Application for Planning Permit

Keep the existing house and subdivide the rear block into 4 more blocks. A total of 5 lot sub division

Objections to an Application for Planning Permit
5 Lot Subdivision
Planning Permit No. PA3085
1 Blackie Avenue, Ararat being
Lot 1 TP430736L, V8806, F706,
Township & Parish of Ararat

Re: Application for Planning Permit No. PA3085
1 Blackie Avenue
5 Lot Subdivision

View through Sunroom Window

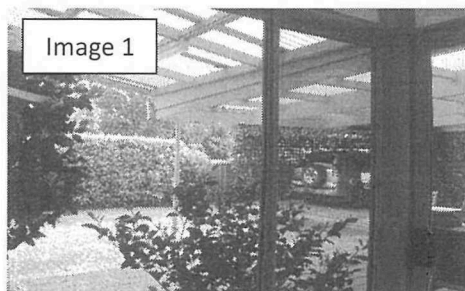
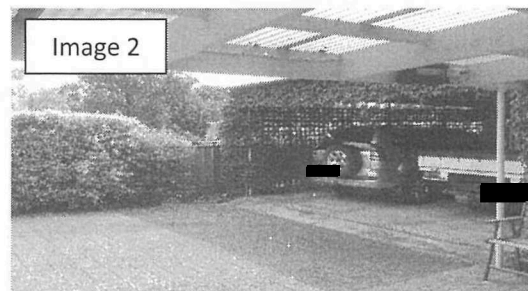
- The proposed dwelling on Lot 2 will be in our direct line of sight from existing windows in our lounge room, sunroom and family room as well as from our alfresco dining and entertaining area and carport / entertaining area. This will create the potential for conflict with future neighbors over privacy issues. Refer Images 1 & 2

- Our block is raised in height ranging from 850mm above the ground level of the proposed Lot 2 at the front of our existing carport / entertainment area to a height of 1400mm at the back of our existing carport / entertainment area. The current view from our existing carport / entertainment area from this raised height is obstructed during the Summer months by the foliage of deciduous vines which grow on the wooden lattice cladding of our carport / entertainment area.

During the Winter months, the leaves on the vines fall off exposing us to a view of the existing Galvanized Steel shed which is situated about 1500mm from the boundary. If the development

goes ahead and the shed is removed as proposed, we will be able to see directly into the proposed 'Private Open Space' of Lot 2, especially during the Winter months when the foliage is gone. We will also be in clear view of the future occupants of Lot 2 while we are on this part of our property. This is a situation we would rather not be presented with because it will detract from our current privacy, lifestyle and enjoyment of our property, as well as creating the potential for conflict with future neighbours over privacy issues. Refer to Image 3.
